STATE OF DELAWARE
EXECUTIVE DEPARTMENT
OFFICE OF STATE PLANNING COORDINATION

RE: Summary of PLUS Reviews for Proposed School Sites
Option 5 – PLUS 2013-11-05 (Rt. 113 and Rt. 9)
Option 6 – PLUS 2013-11-01 (Rt. 113 and Trap Pond Rd.)
Option 7 – PLUS 2013-11-06 (Sand Hill Road)

RE: PLUS review 2013-11-06; Sussex Tech School District (Option 7)

Sussex Vocational School District - Environmental Data Option 5

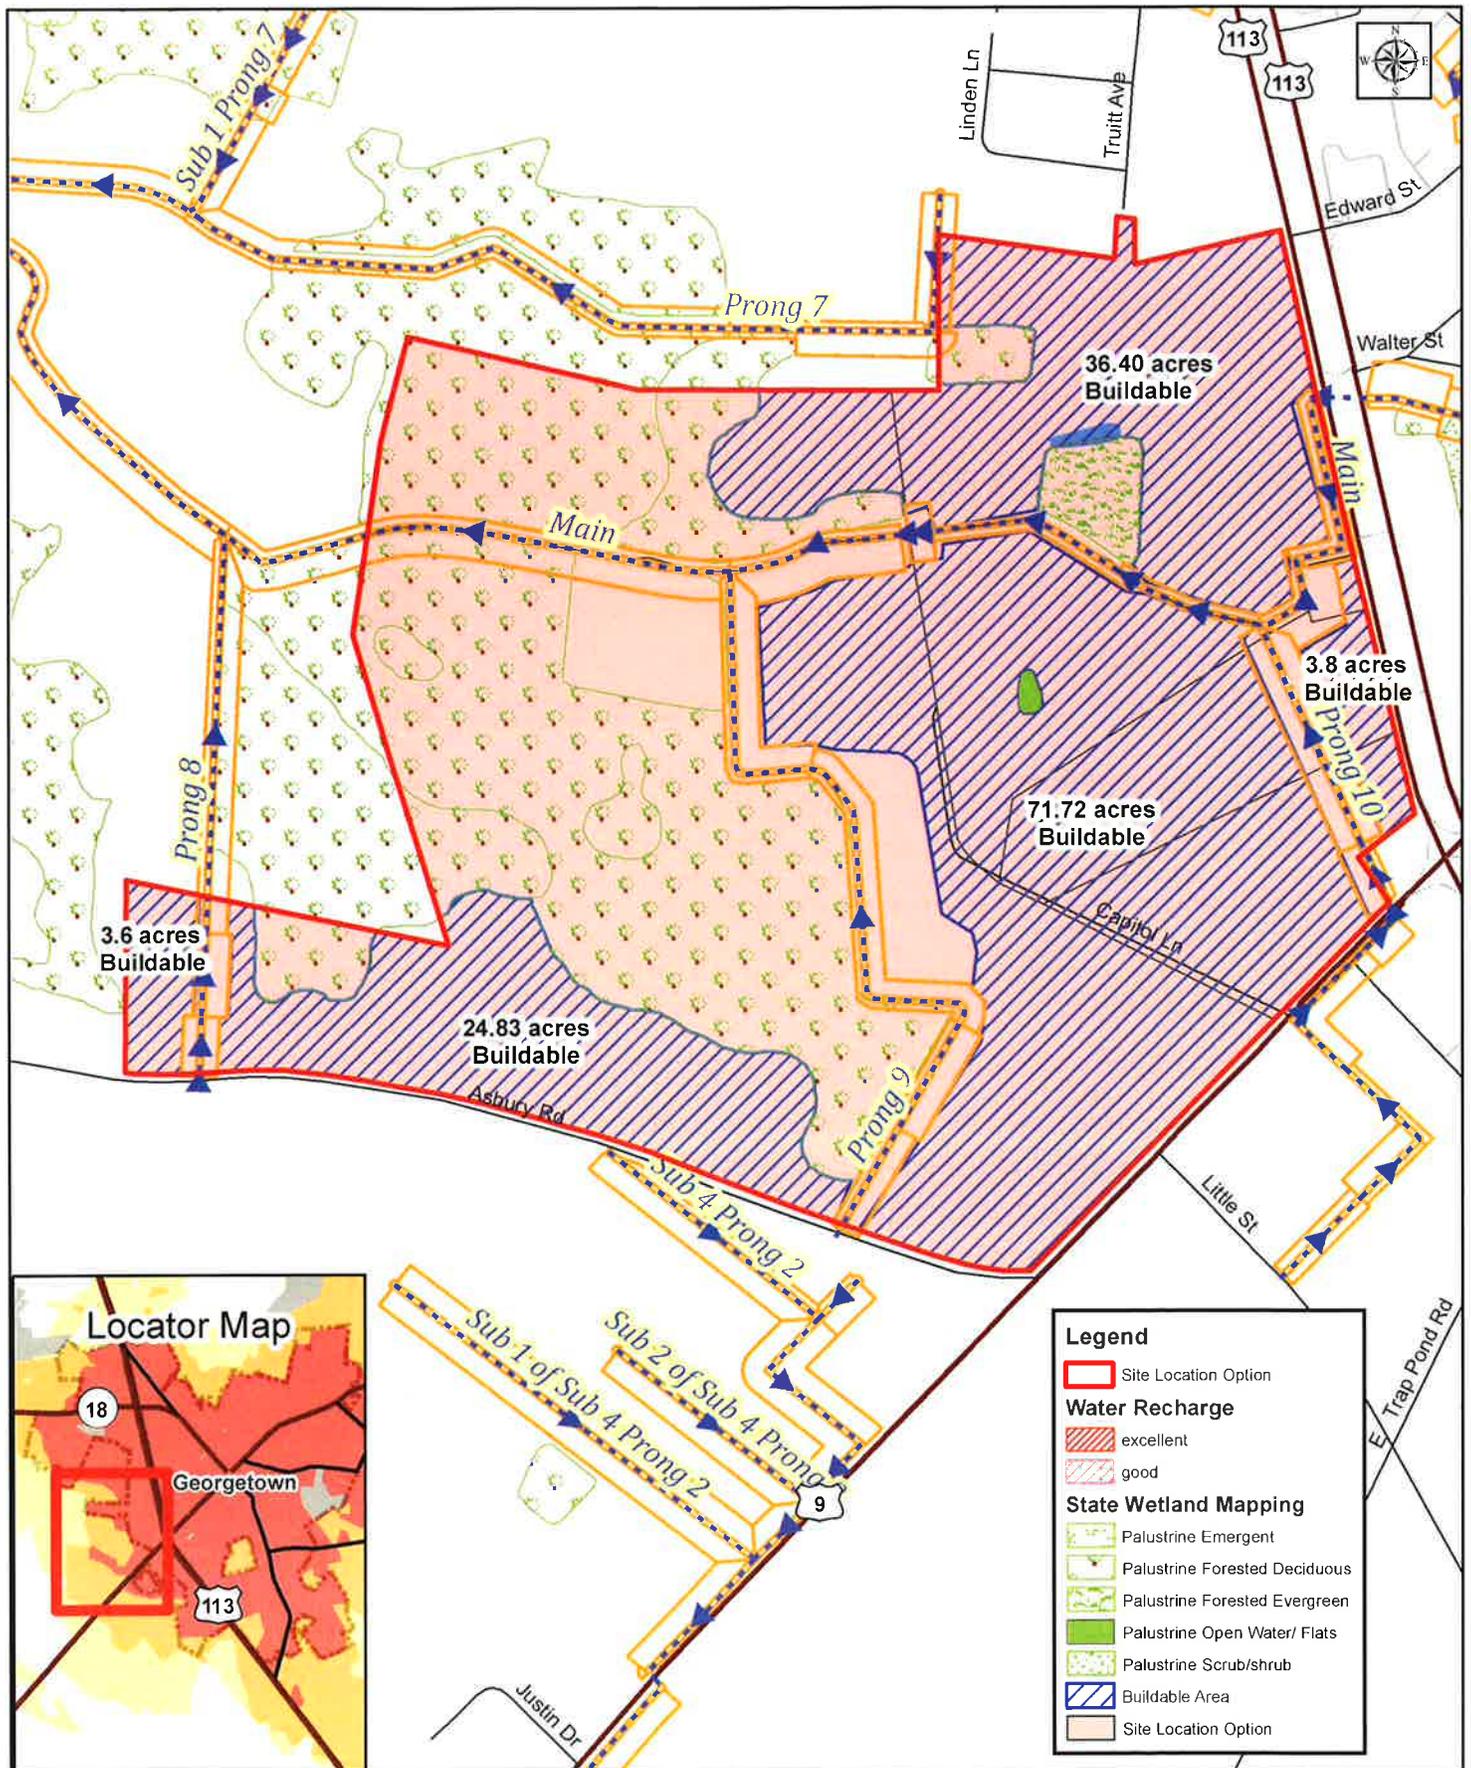
- This site is our most preferred option for school construction among these three proposals, and in fact among all sites proposed so far.
- The detailed environmental analysis completed using GIS data indicates that approximately 142 acres are buildable for school construction. Detailed wetlands delineations and soils testing will be required to field verify this finding.

- The largest block of buildable land is approximately 71 acres, and would be a good place to construct the school with access to Rt. 9 and /or Asbury Rd.

- Two smaller blocks of buildable land of approximately 36 and 24 acres would perhaps be suitable for the construction of athletic fields or other facilities to support the school and its mission.

- The site contains an extensive tax ditch network which will probably have to be preserved in-tact to provide for drainage. The ditches can be bridged to allow access across them, but neither the ditches nor the right of way can be built upon.

- The site contains wetlands that will have to be delineated and preserved.
- Compliance with the stormwater management regulations will be required. We are aware that the District has already hired engineers to investigate this issue.

Sussex Vocational School District - Environmental Data Option 6

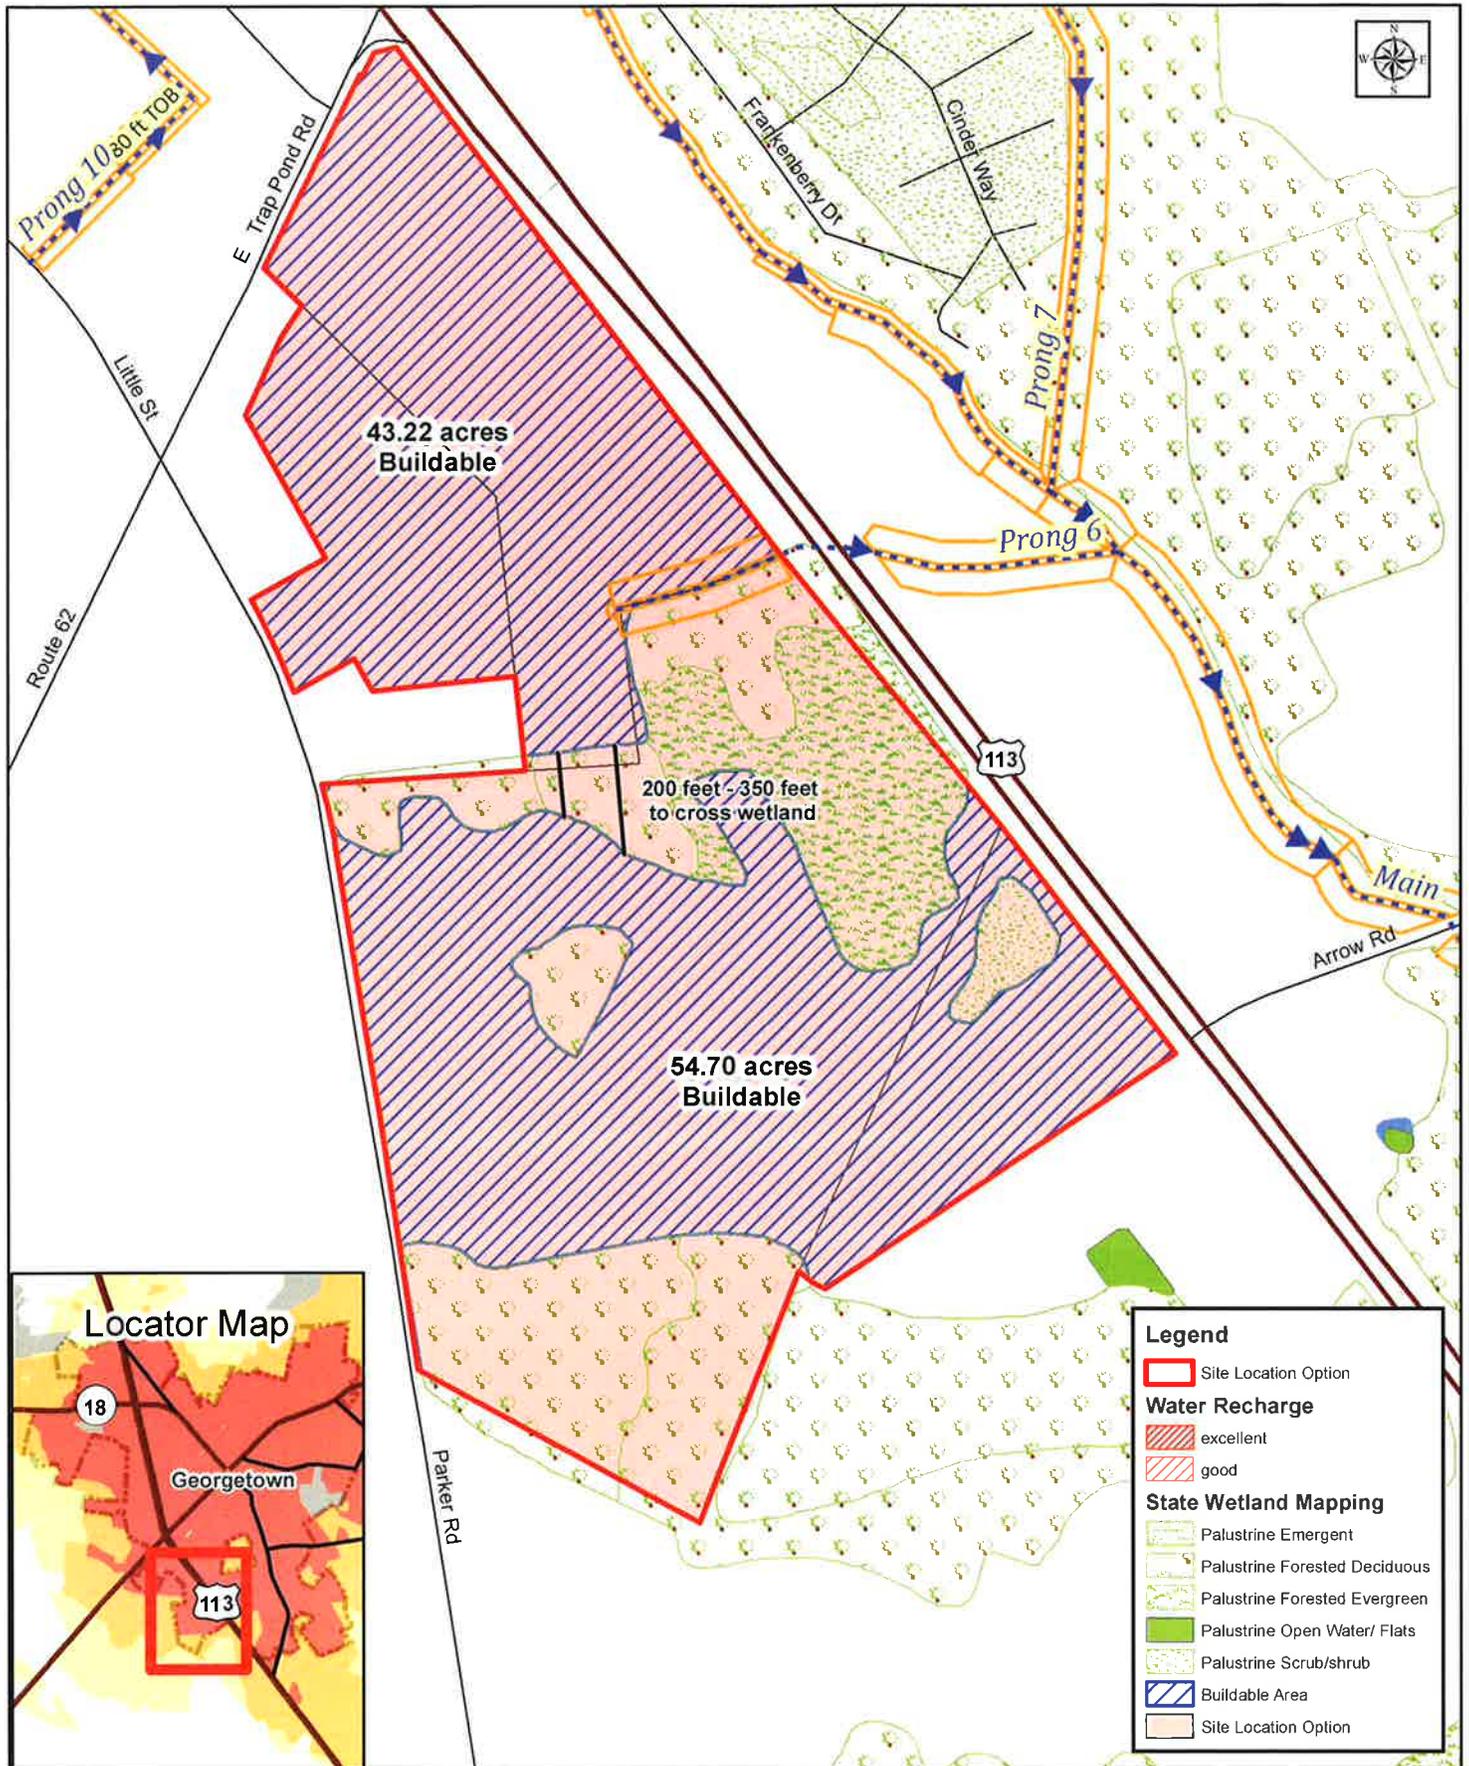
- The detailed environmental analysis completed using GIS data indicates that approximately 98 acres are buildable for school construction. Detailed wetlands and soils testing will be required to field verify this finding.

- The site contains two buildable areas of approximately 43 and 54 acres respectively.
 - These buildable areas are separated by wetlands. It appears to be possible to bridge the wetlands area to connect the two halves of the site. Clearly, this is not ideal.

- Detailed site planning will be necessary to determine whether or not the school and all of its required parking and facilities could be constructed in one of these buildable areas, leaving the other for the construction of the athletic fields.

- The site contains tax ditches. It appears that these tax ditches could be moved if necessary.
- The site contains wetlands that will have to be delineated and preserved.

Sussex Tech Option 7 PLUS 2013-11-06

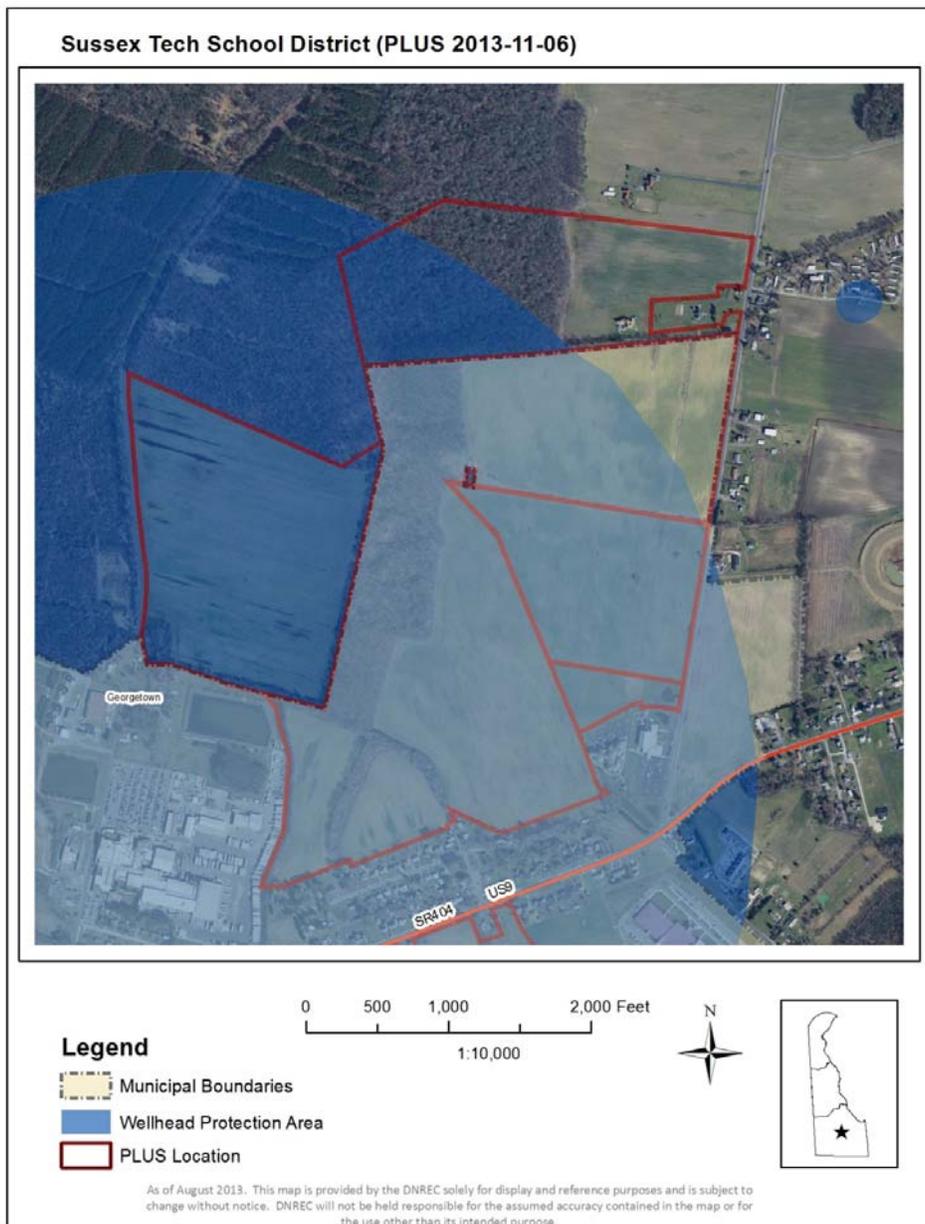
- State regulated wetlands ARE NOT located on this property based on a review of the State wetland maps. State regulated wetlands are those wetlands identified on the State's official State Regulated Wetland Maps. Additional information about State regulated wetlands is available by contacting the Wetlands and Subaqueous Lands Section at (302) 739-9943 or on line at <http://www.dnrec.delaware.gov/wr/Services/Pages/WetlandsAndSubaqueousLands.aspx>.

- State regulated subaqueous lands ARE likely to be located on this property based on a review of aerial photographs, SWMP maps, Soil Surveys and/or USGS topographic maps. A stream or tax ditch is located on these parcels. DNREC recommends a delineation be done for these subaqueous areas. State subaqueous lands include all tidal waters (up to the mean high water line), most non-tidal rivers, streams, lakes, ponds, bays and inlets (up to the ordinary high water line), most perennial streams and ditches and many intermittent streams and ditches. Additional information about State regulated subaqueous lands is available by contacting the Wetlands and Subaqueous Lands Section at (302) 739-9943 or on line at <http://www.dnrec.delaware.gov/wr/Services/Pages/WetlandsAndSubaqueousLands.aspx>.

- Waters of the U.S. regulated by the U.S. Army Corps of Engineers ARE likely to be located on this property based on a review of aerial photographs, SWMP maps, Soil Surveys and/or USGS topographic maps. DNREC recommends that a wetland delineation be done by a licensed consultant. Waters of the United States include the following: navigable waters of the United States; wetlands; tributaries to navigable waters of the United States, including adjacent wetlands and lakes and ponds; interstate waters and their tributaries, including adjacent wetlands; and all other waters of the United States not identified above, such as isolated wetlands, intermittent streams, and

Figure 1a: NRCS soil mapping units in the immediate vicinity of the proposed project

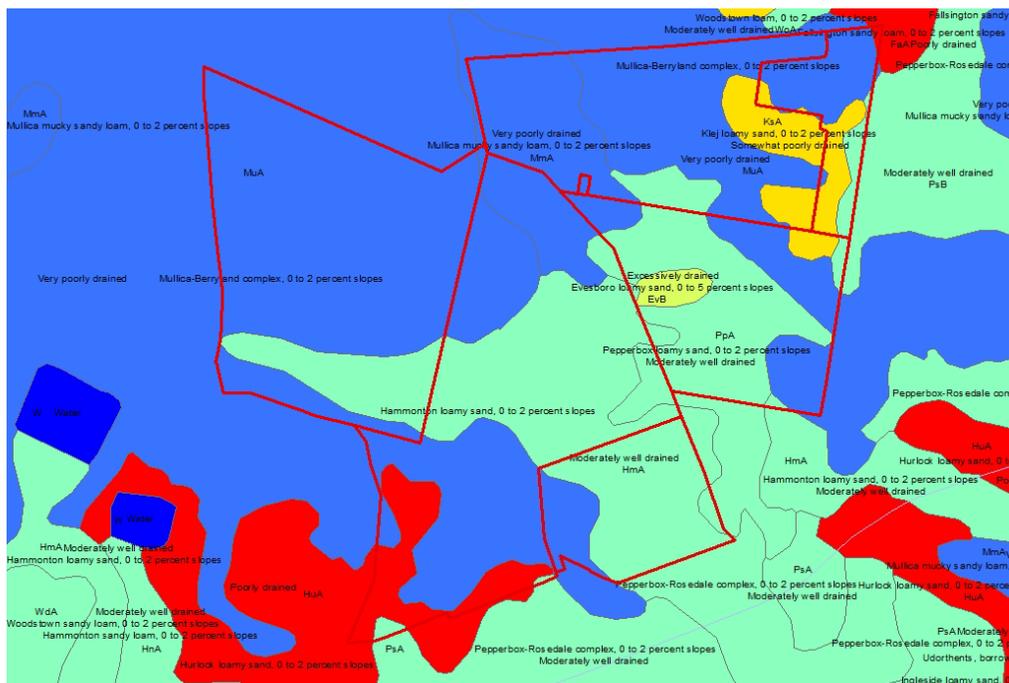
- Based on information in the NRCS soil survey, approximately 50% of the mapped acreage in this parcel is comprised of poorly to very poorly-drained wetland associated hydric soil mapping units (e.g., Mullica (MmA) & Hurlock (HuA)). As mentioned previously, poorly or very poorly-drained wetland associated hydric soils are indicative of wetland conditions and are considered unsuitable for development due to their higher probability/susceptibility to onsite and off-site flooding potentials.

- This project appears to be feasible for siting the school if the project is confined to the non-hydric soil mapping units (e.g., Hammonton (HmA), Pepperbox (PpA), & Evesboro (EvB)). Also, since this parcel's proposed project area contains a greater proportion of its' land acreage in non-hydric soils and uplands (Figure 1a & 1b) relative to the other two evaluated parcels; this parcel by default, is the most favorable location for building the proposed school. Sediment and Stormwater Program as well as the Drainage Program do not recommend this site due to the absence of a suitable outlet for discharging stormwater runoff during the larger storm events. While the site soils at Option 7 may be more suitable than Options 5 and 6 for construction of the building based on soil mapping, on Site Option 7 there is nowhere to direct the runoff from the site in large storm events which will result in flooding on the site and/or surrounding parcels.
